Introduction

The parent device is Cisco Catalyst 9136I Access Point (Model: 9136I, FCC ID: LDKVEHVR2777, 2461N-VEHVR2777) working in 5/6 GHz and it follows FCC Part 15.407 rule. The variant device to be certified is Cisco Catalyst 9136I Access Point (Model: 9136I, FCC ID: LDKMU6CR2417, IC: 2461N-MU6CR2417) working in 5/6 GHz and it follows FCC Part 15.407 rule. Both the parent and variant devices comply with the DFS requirements in the 5 GHz band, as specified in FCC Part 15.407(h)(2) and FCC KDB 905462 D02. The new firmware will enable Ultra-Reliable Wireless Backhaul (URWB) technology, which introduces two additional DFS modes: Point-to-Multipoint (P2MP) and Client with Radar Detection. The applicant takes full responsibility and that the test data as referenced represents valid data for demonstrating compliance for the variants listed in the application.

Similarity Illustration

Integration scanning radio card into mother board

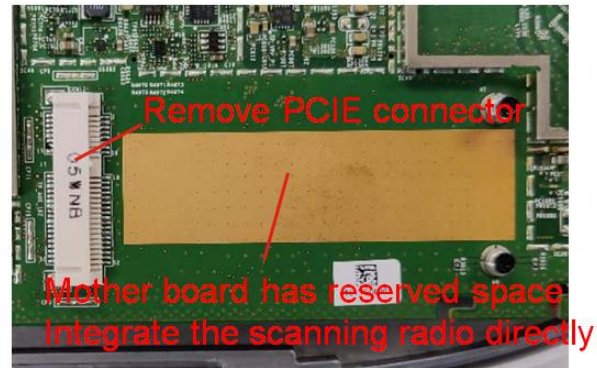
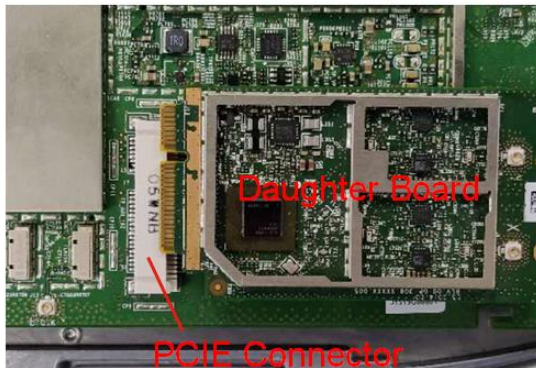
- Maui: Scanning radio is on daughter board, connect to mother board with PCIE connector.
- Maui VE: Remove PCIE connector, integrate the scanning radio on mother board directly.

Removal of USB3.0 circuitry/components

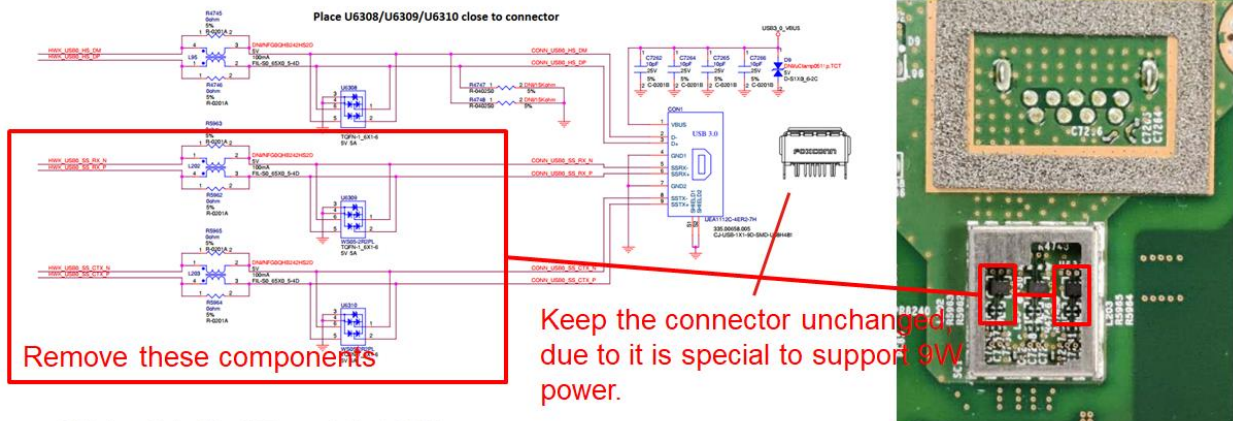
- USB3.0 is not supported as customer spec, replace with USB2.0

Replace discrete Ethernet transformer with ordinary transformer

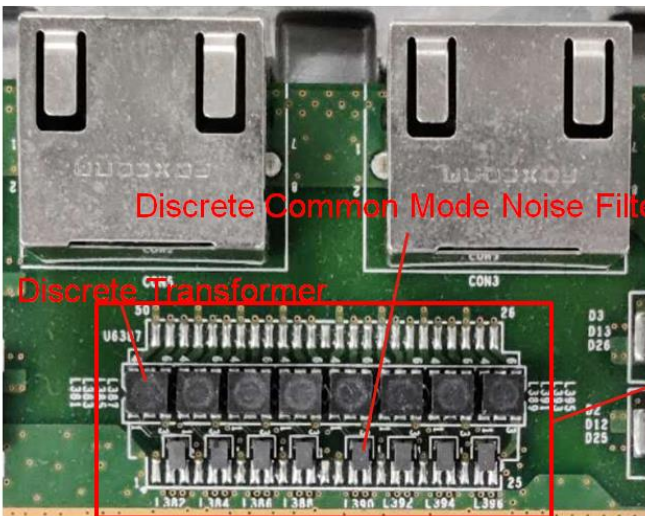
Replace with ordinary transformer
